**DEPARTMENT OF PLANNING
STAFF REPORT**

SUBJECT: SPEX-2013-0040 and CMPT-2013-0015, Loudoun Water 600 Zone, Red Hill Road Water Storage Tanks

SUBJECT: SPEX 2013-0040, SPMI 2013-0010 & CMPT 2013-0015
Loudoun Water 600 Zone-Red Hill Road

600 Zone Tanks Visual Assessment: Tank Visibility

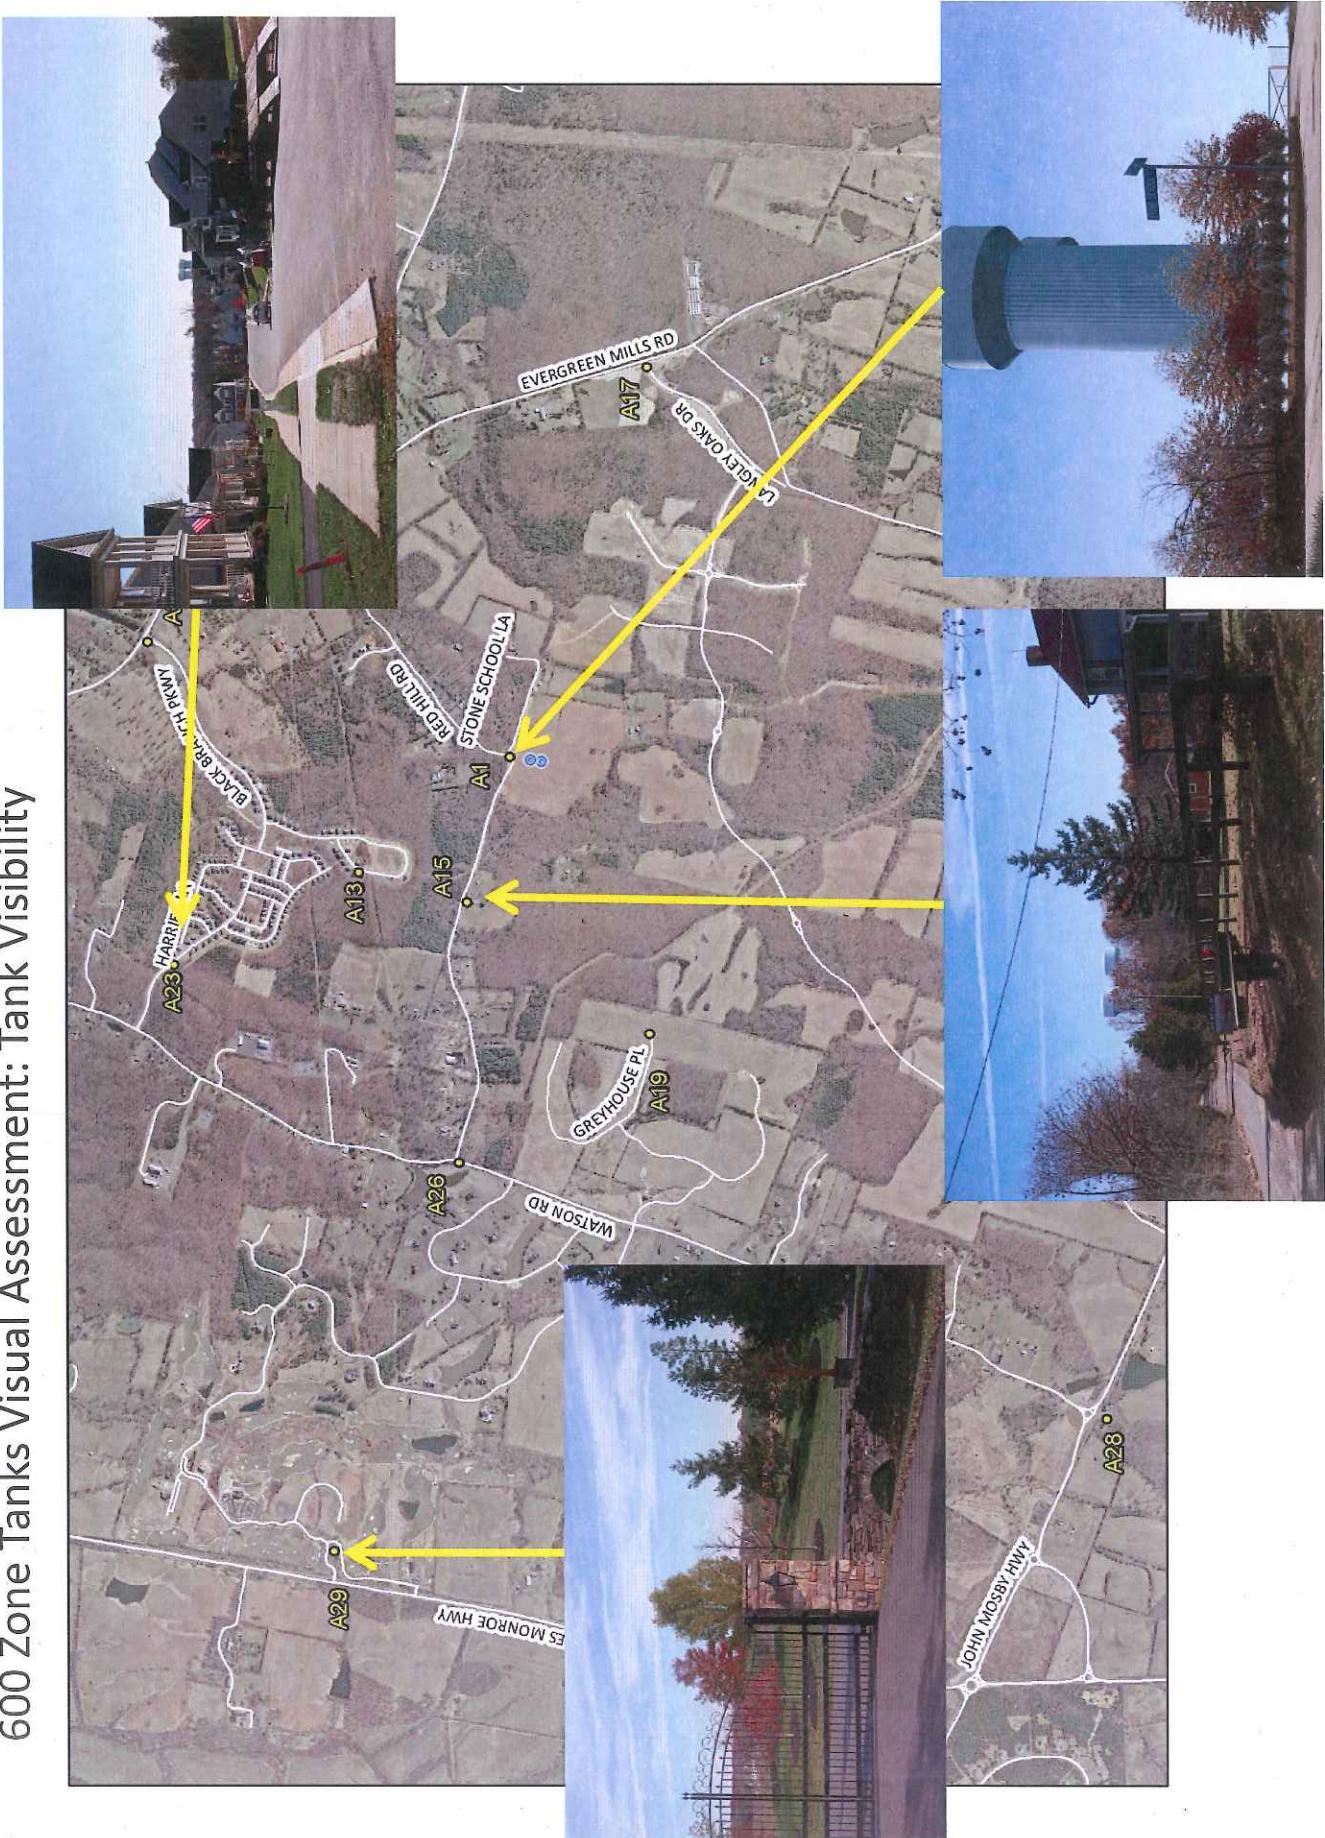
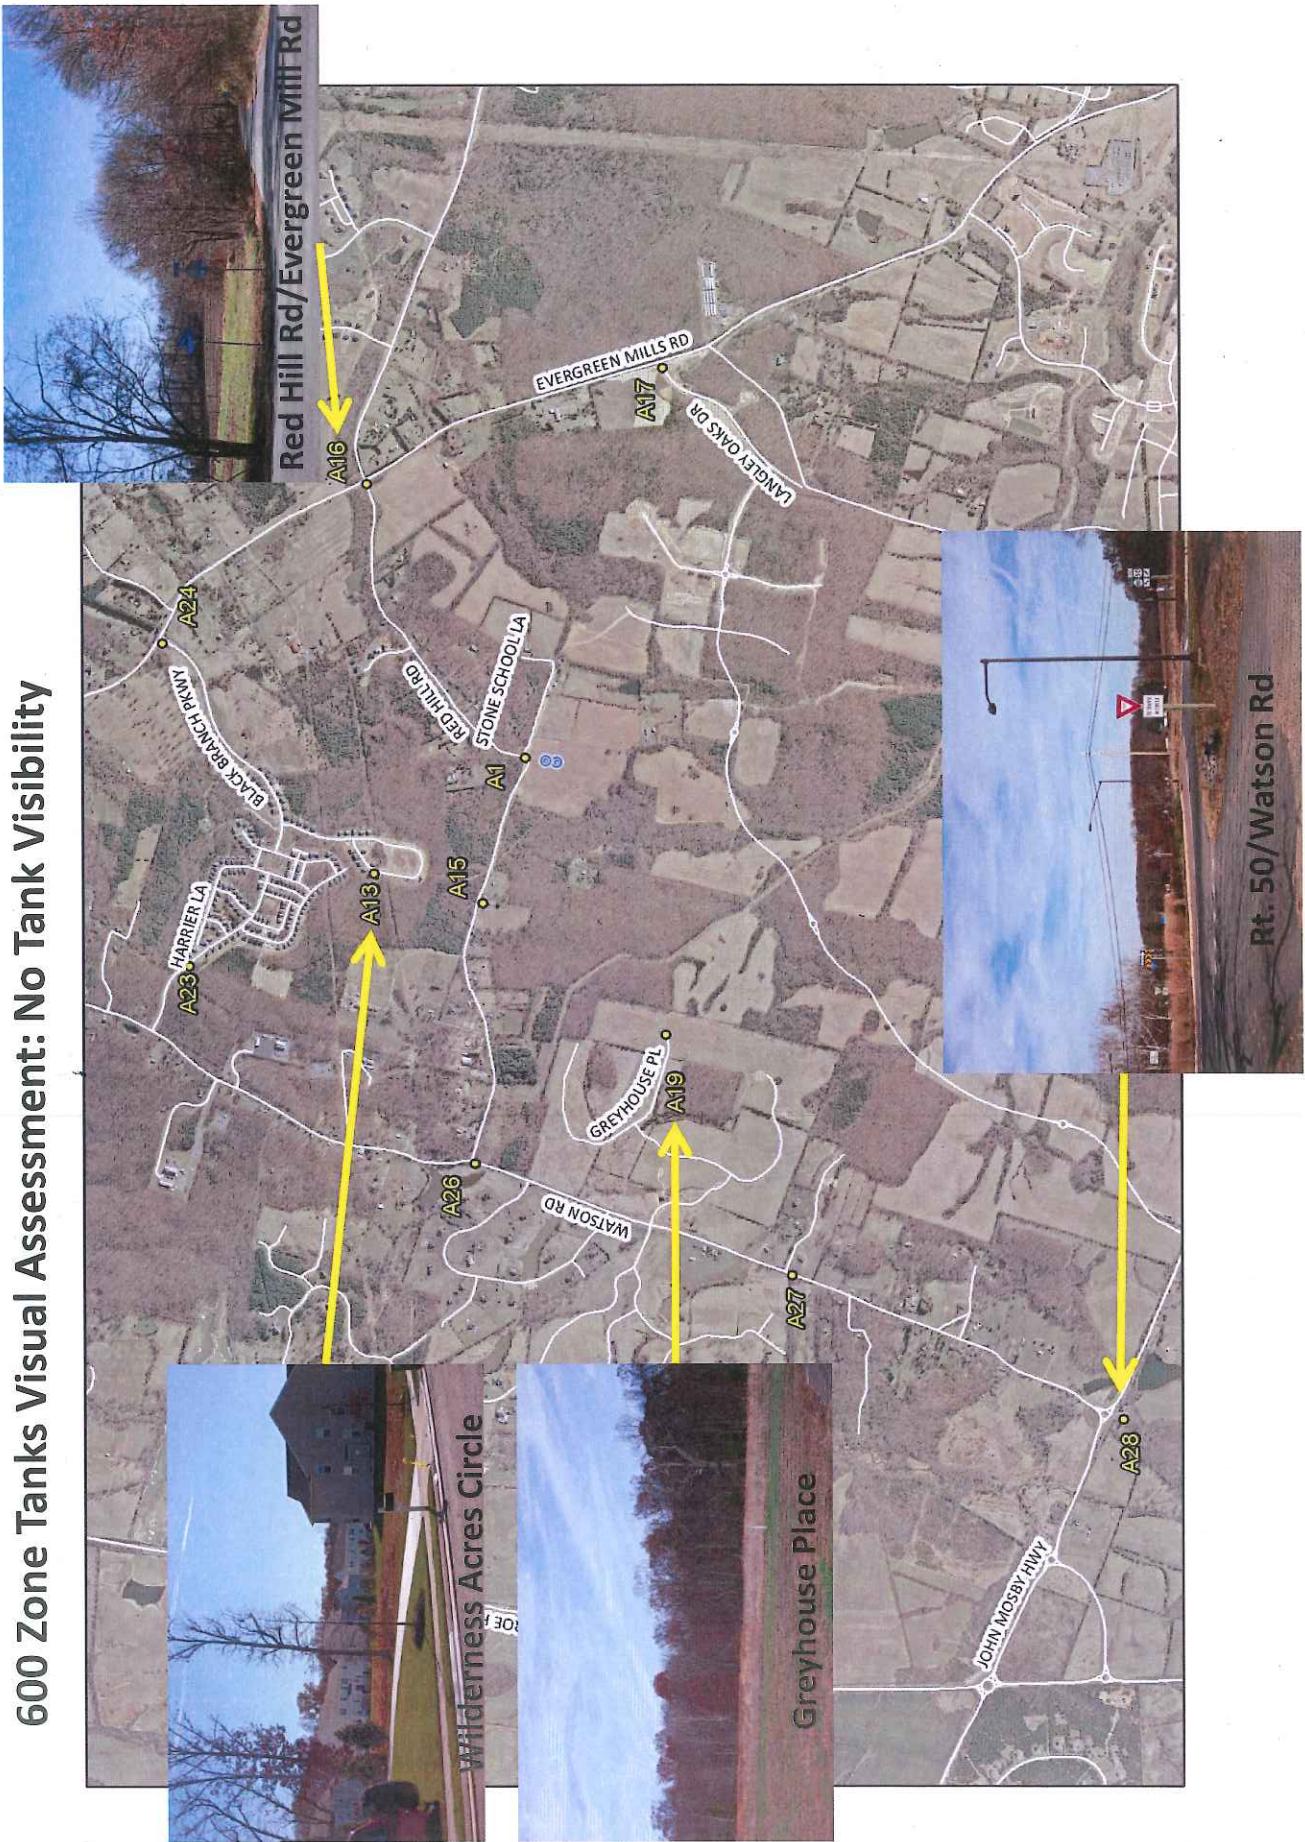
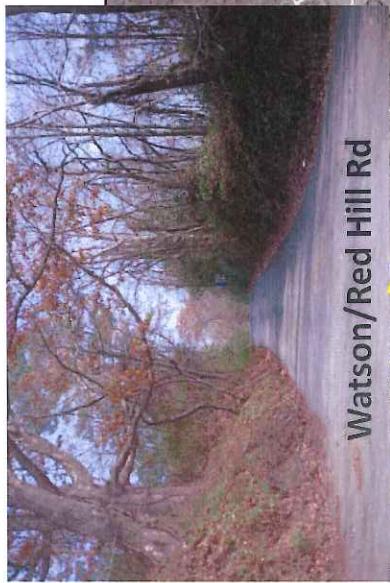
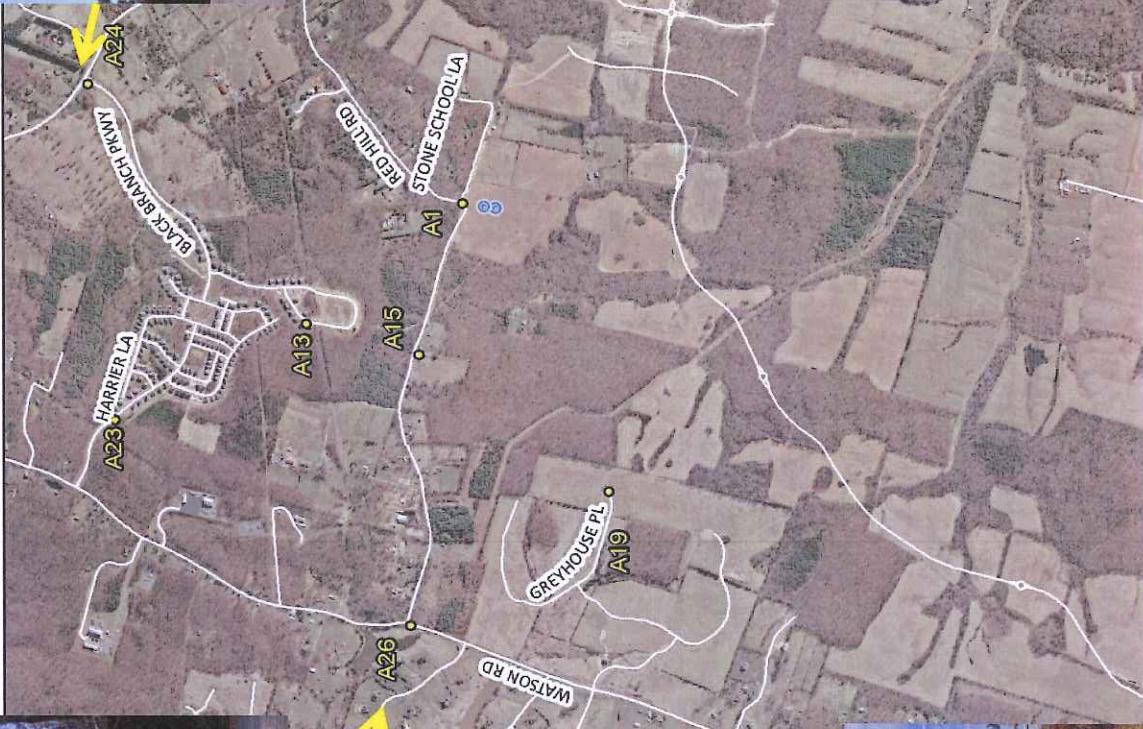
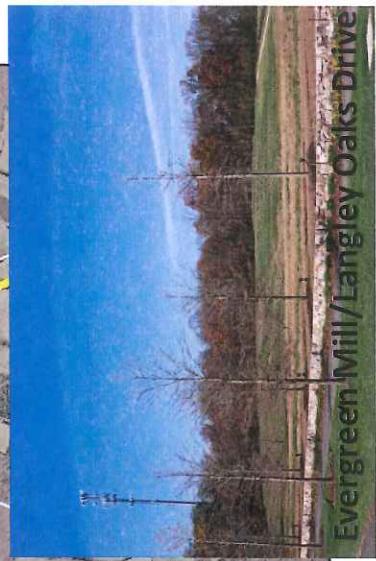
Response: Included with this resubmission are additional photos to aid in the assessment of the views from the aforementioned areas. The balloon used in the tank simulation process was not visible from locations identified as Photos A16 and A17 taken along Evergreen Mills Road at Red Hill Road and Langley Oaks Drive, respectively. Fleetwood Farm is located along Evergreen Mills Road between these two locations. Further, a review of area topography and development patterns along the line of sight between Fleetwood Farm and the Application Property confirmed that higher elevations and substantial tree cover would limit if not eliminate the potential for tank visibility once they were constructed.
